SUNDRY NOTICES AND REPORTS ON WELLS
Do not use this form for proposals to drill or to re-enter an abandoned well. Use form 3160-3 (APD) for such proposals.

Cimarex respectfully requests approval to plugback from the morrow, perforate and recomplate into the Cisco Canyon & Wolfcamp. Cimarex also proposes to downhole commingle production from the Cisco Canyon and Wolfcamp zones. Please see attached recompletion procedure for your approval.

Black River 10 Federal Com #1

Permanent Abandonment of Production Zone Conditions of Approval

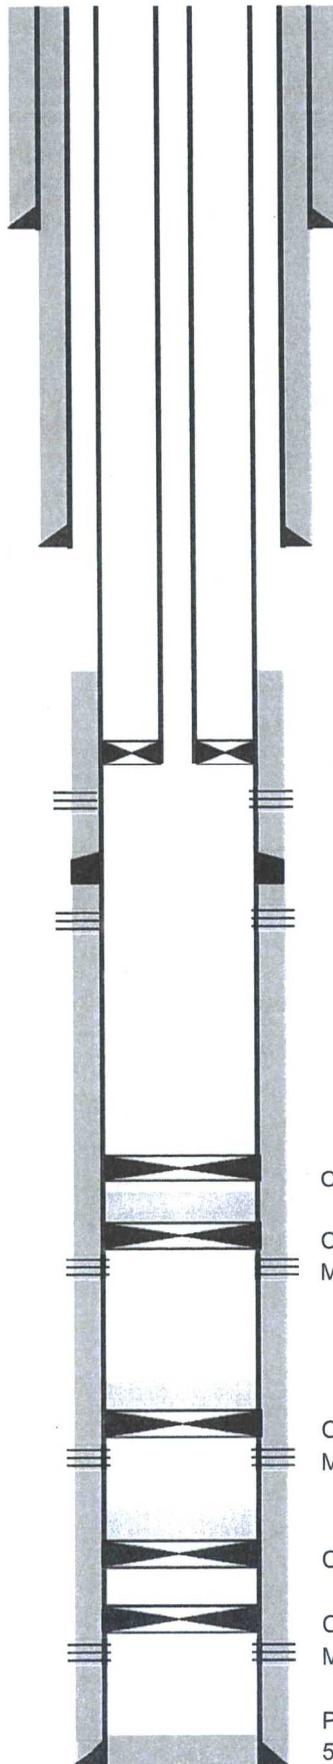
On top of CIBP at 11,290' and 11,079', 35 feet of cement is needed.
